CLUBHOUSE

BRADLEY HEIGHTS APARTMENTS

Clubhouse
Cover Sheet

Clubhouse Occupancy Diagram

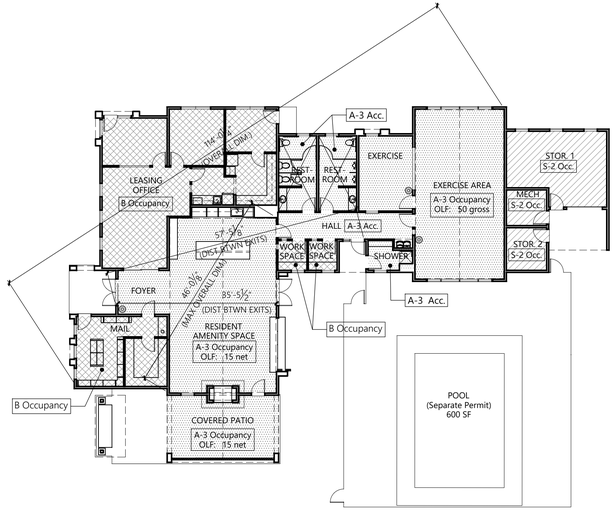
Revise to correct occupant load of 150 gross for Business use per Table 1004.5 Page A1

CLUBHOUSE PARTIAL FLOOR PLAN

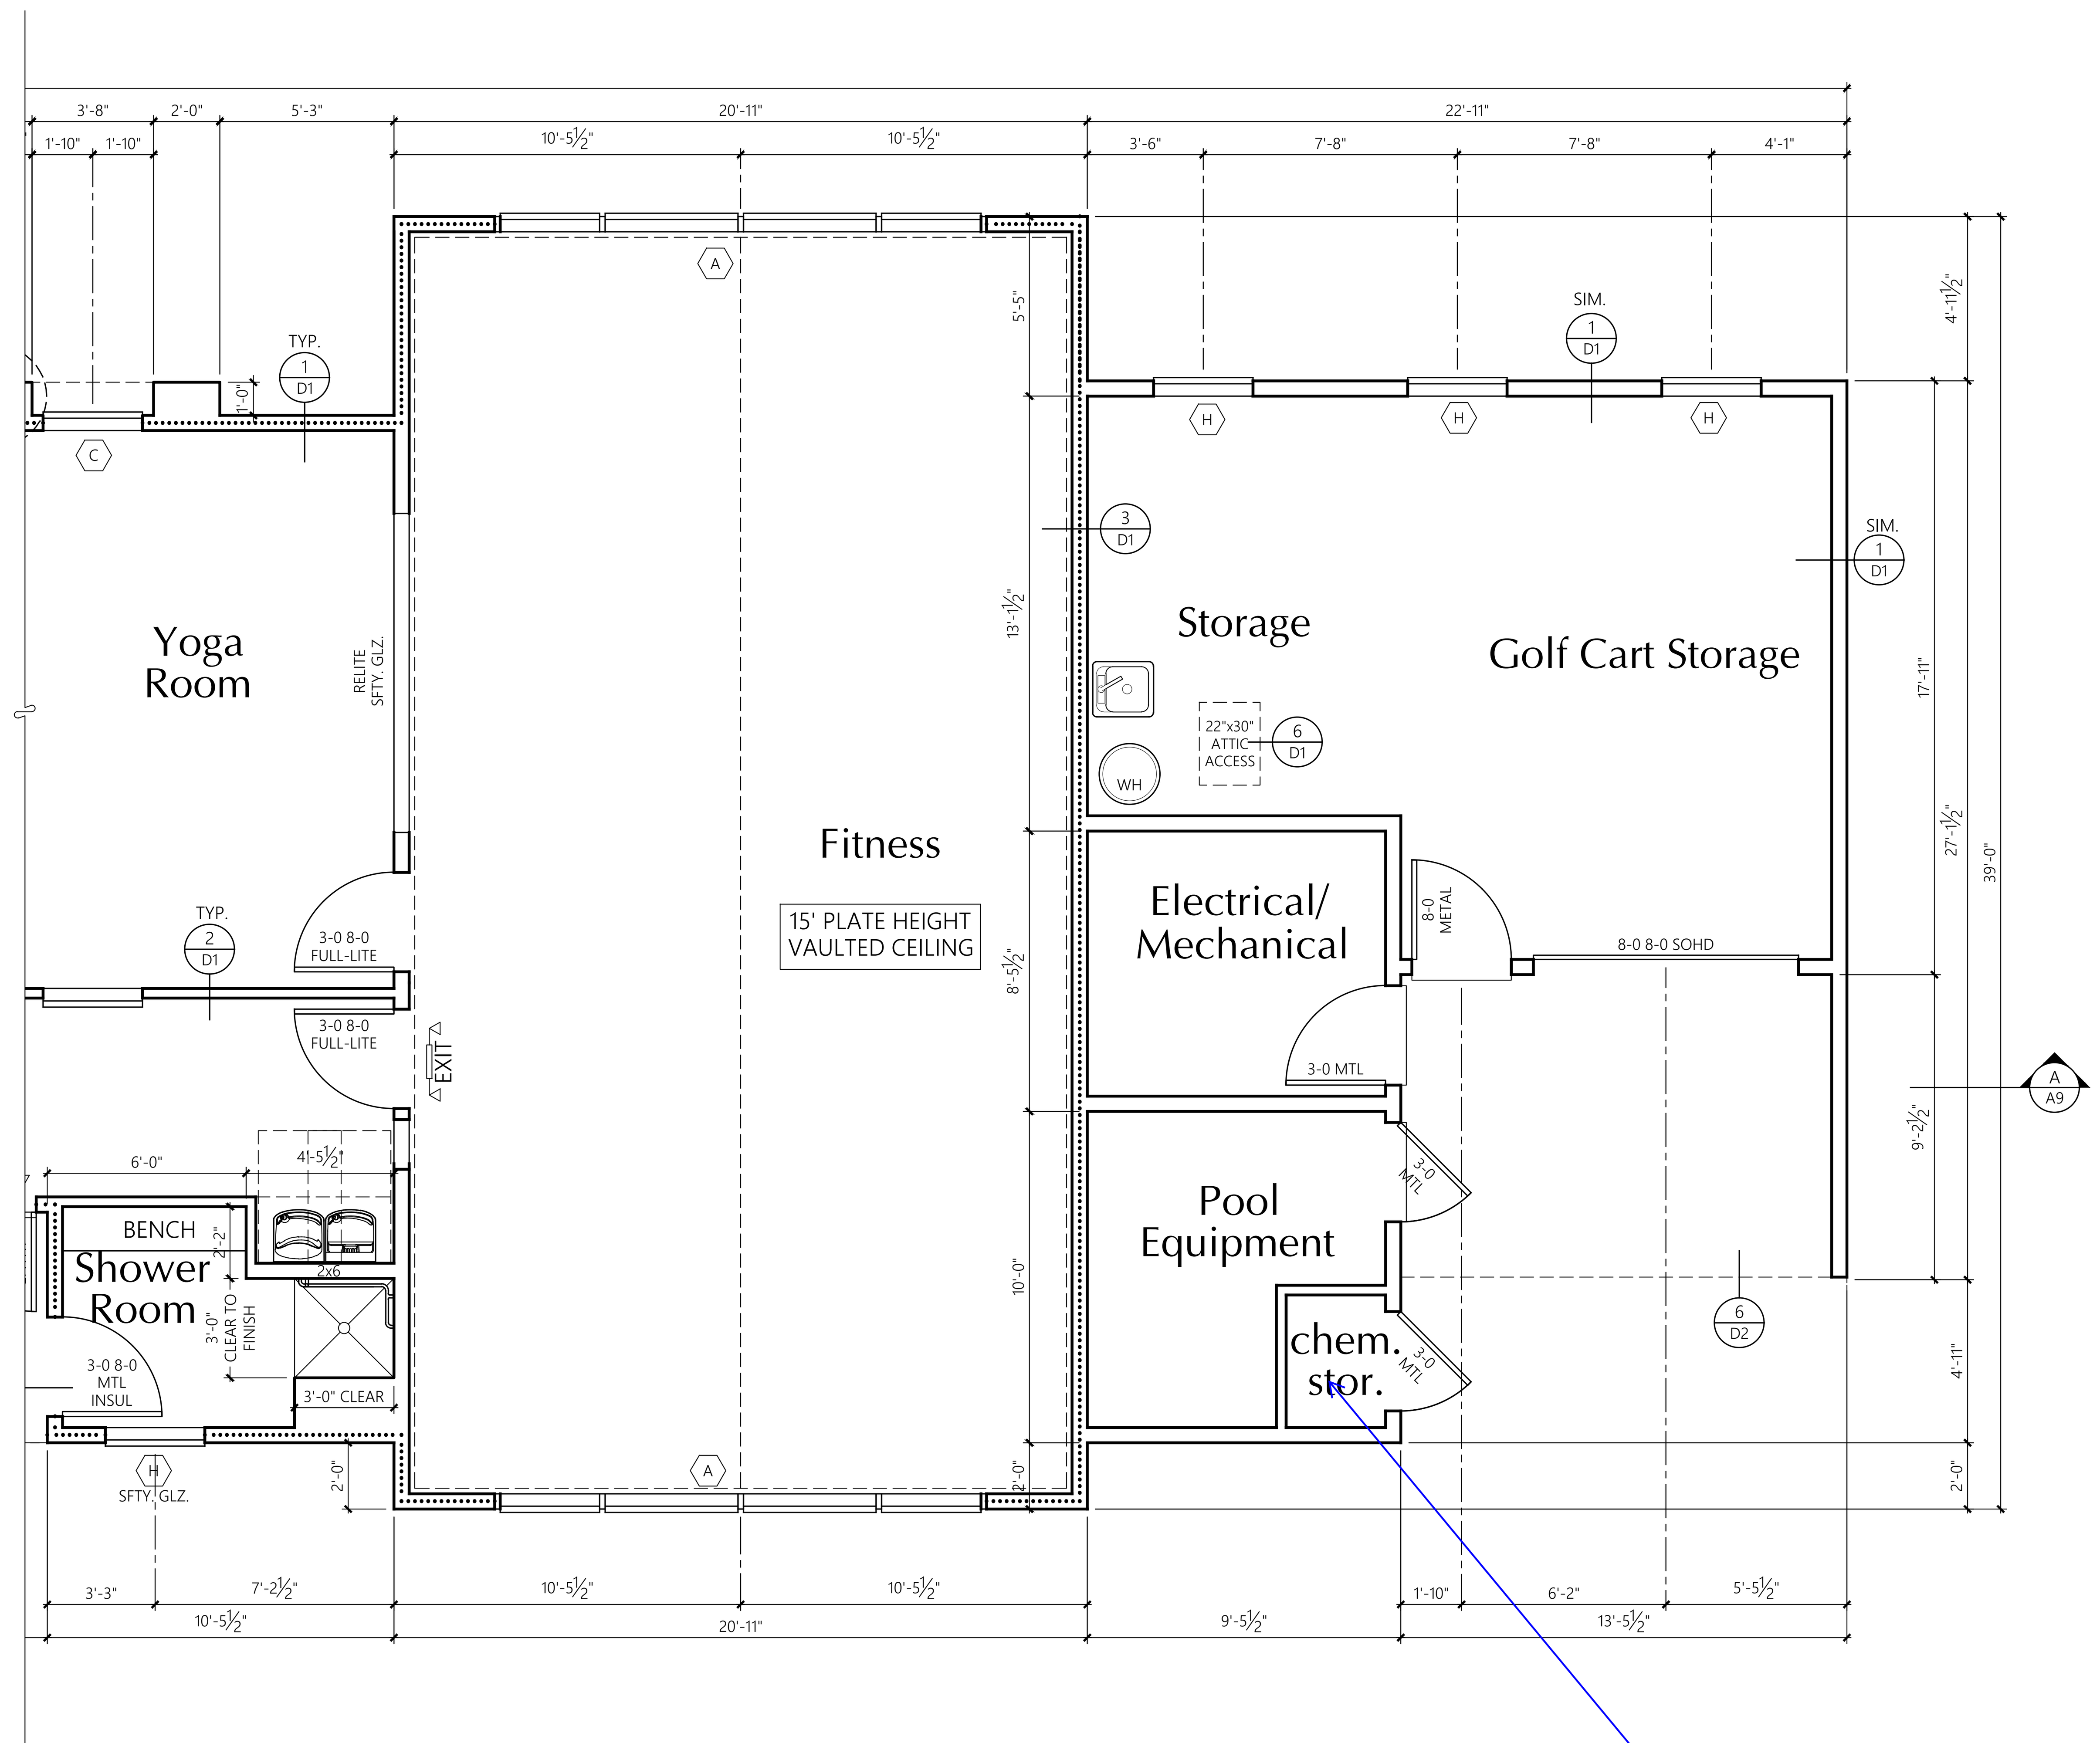
Depict and label the proposed mop sink in the storage area and the proposed floor drain. [CONSTRUCTION PLAN SET, sheet A9]

CLUBHOUSE NORTH (27TH AVE) ELEVATION

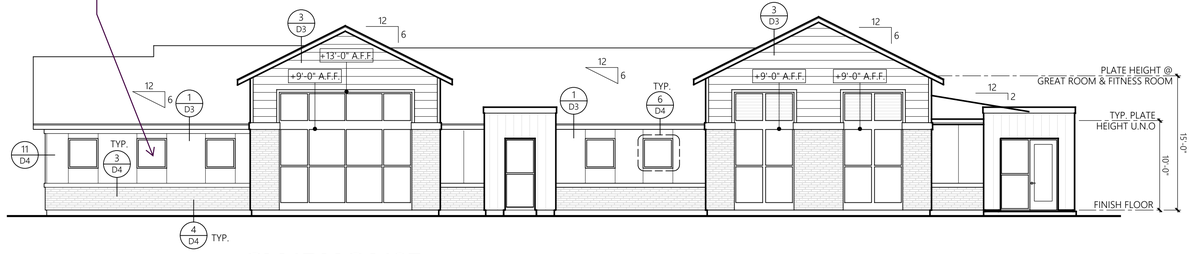
Demonstrate that 30% glazing requirement has been met on North Elevation. 30% glazing is only required in the 'pedestrian view plane' located between 2ft and 8ft from the ground.
